SUBJECT: REQUEST FOR ADDITIONAL INFORMATION - DAVIS-BESSE NUCLEAR  
POWER STATION (TAC NO. MB8953)

REQUEST FOR ADDITIONAL INFORMATION  
DAVIS-BESSE NUCLEAR POWER STATION  
DOCKET NO. 50-346

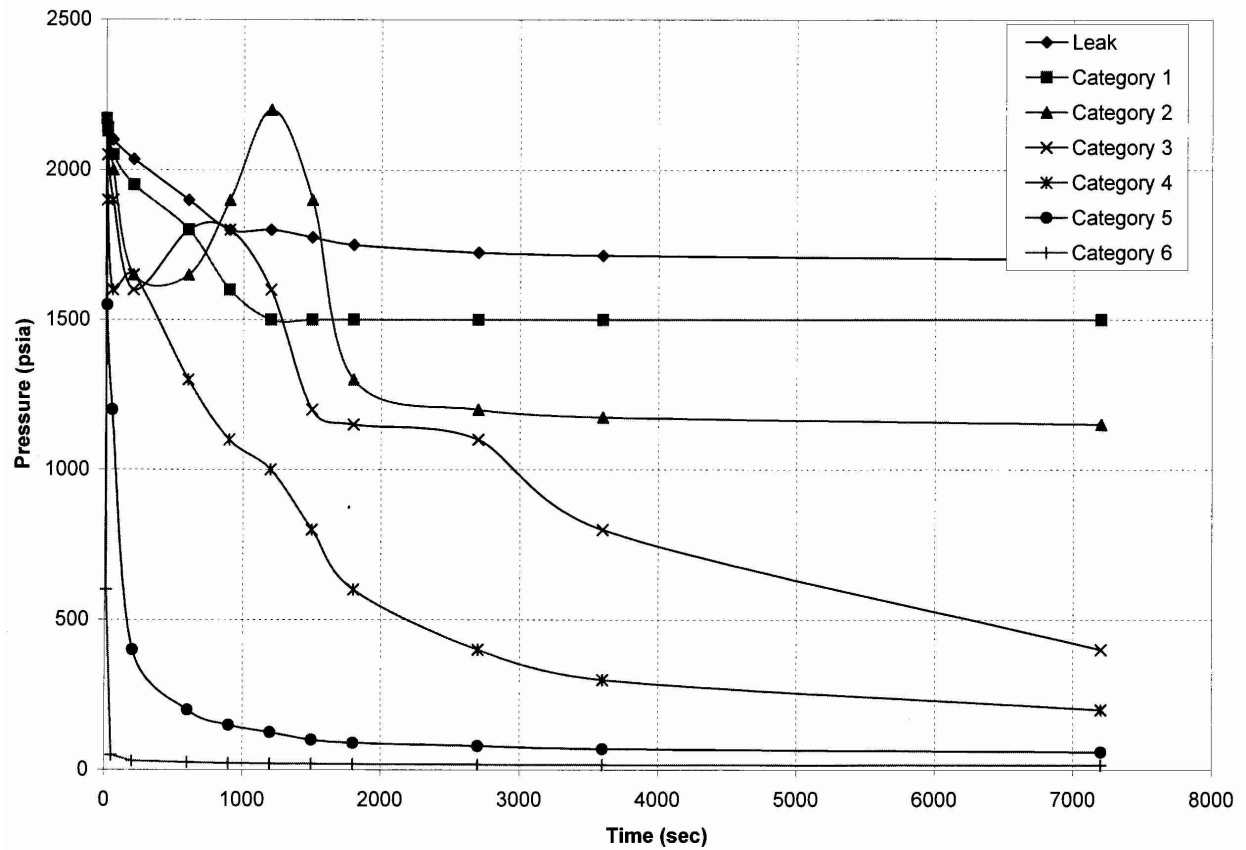
32. The ANP discussion appears to focus on one train of ECCS (or one HPI) being in operation. (See, for example, the last line of Page 25, although there are many examples in the following pages.) Is this correct? If so, do two trains exacerbate the potential concern? See also our question pertaining to MU pump operation.
38. The ANP Page 44 discussion indicates a 3.5 percent head reduction was assumed for HPI flow rate. Is this a conservative assumption when the concern involves HPI flow causing RCS pressure to remain high?

Mode 3 Pressure-Time Histories

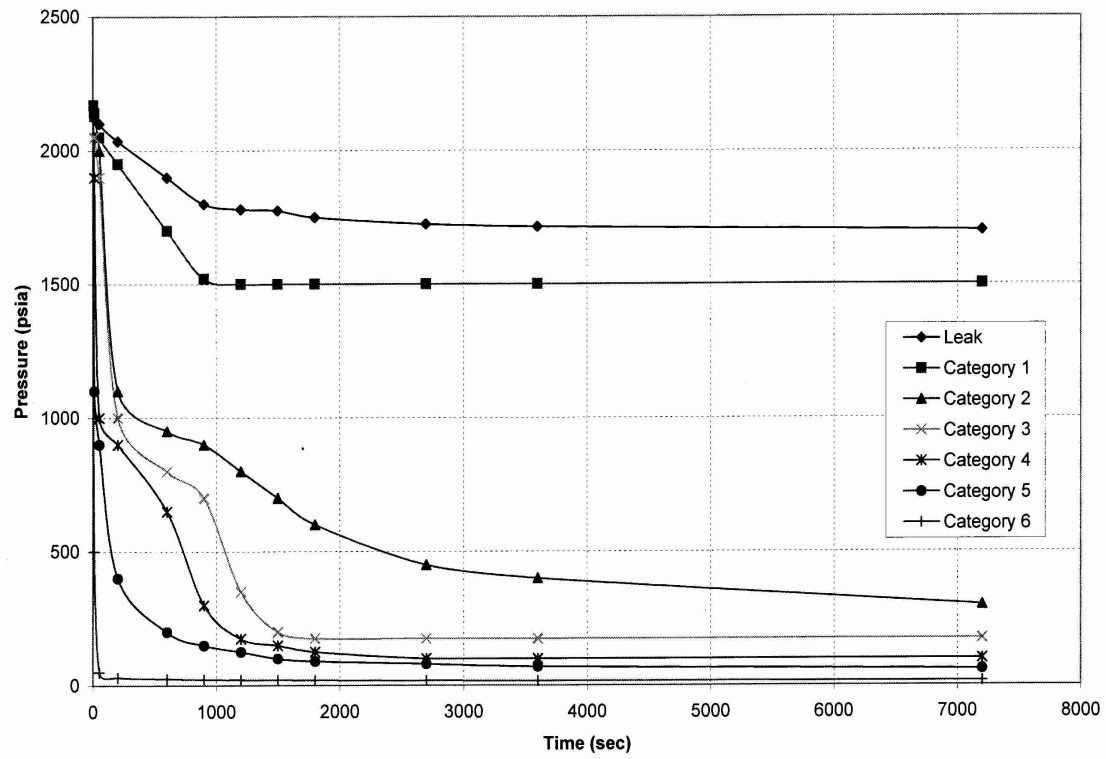
41. Please address training of the affected Technical Support Center staff with respect to the Emergency Operating Procedure changes relative to this limited exception.
42. Provide a summary of Emergency Operating Procedure changes that will be made relative to this limited exception.
43. Provide docketed copy of the RCS pressure/time histories (full power as well as Mode 3) as supplied by FANP.

The following preliminary copies of LOCA response were provided at Lynchburg, VA:
